**RE: The Peaks by Markana
Conceptual Grading & Drainage Plan
Engineer's Stamp Date: 02/25/21
Hydrology File: C18D088**

Based upon the information provided in your submittal received 02/25/2021, the Conceptual Grading & Drainage Plan is approved for Grading Permit and for action by the DRB on Platting action, Site Plan for Building Permit and Site Plan for Subdivision.

PROJECT NAME:
THE PEAKS
BY MARKANA

| C-101 | | CONCEPT GRADING PLAN | |

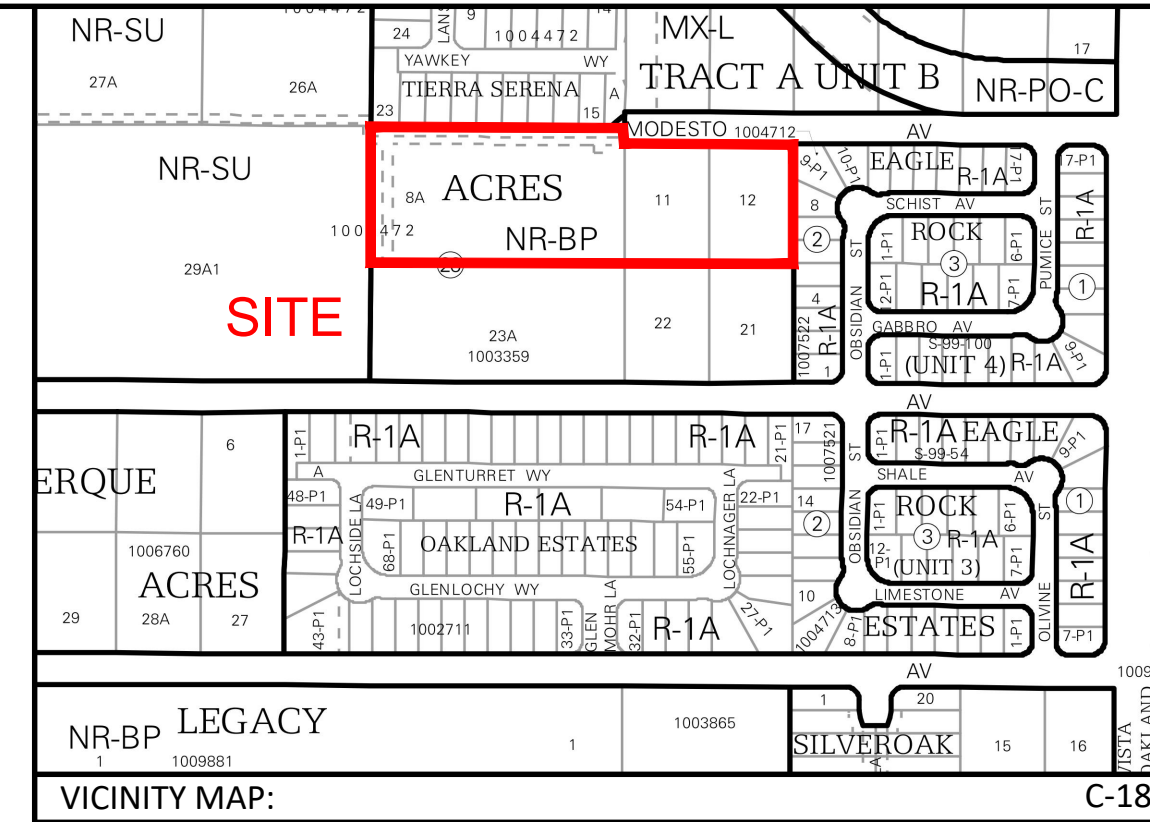
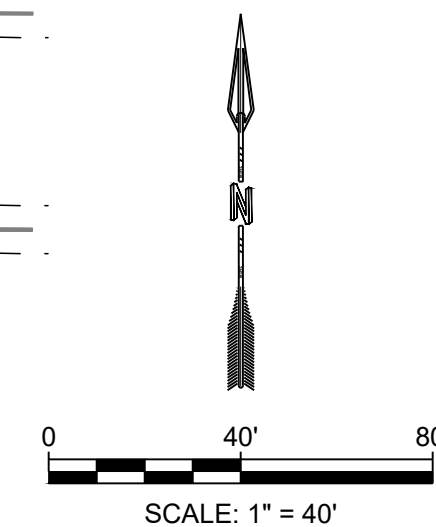
THESE PLANS AND/OR REPORT ARE
CONCEPTUAL ONLY. MORE INFORMATION MAY
BE NEEDED IN THEM AND SUBMITTED TO
HYDROLOGY FOR BUILDING PERMIT APPROVAL.
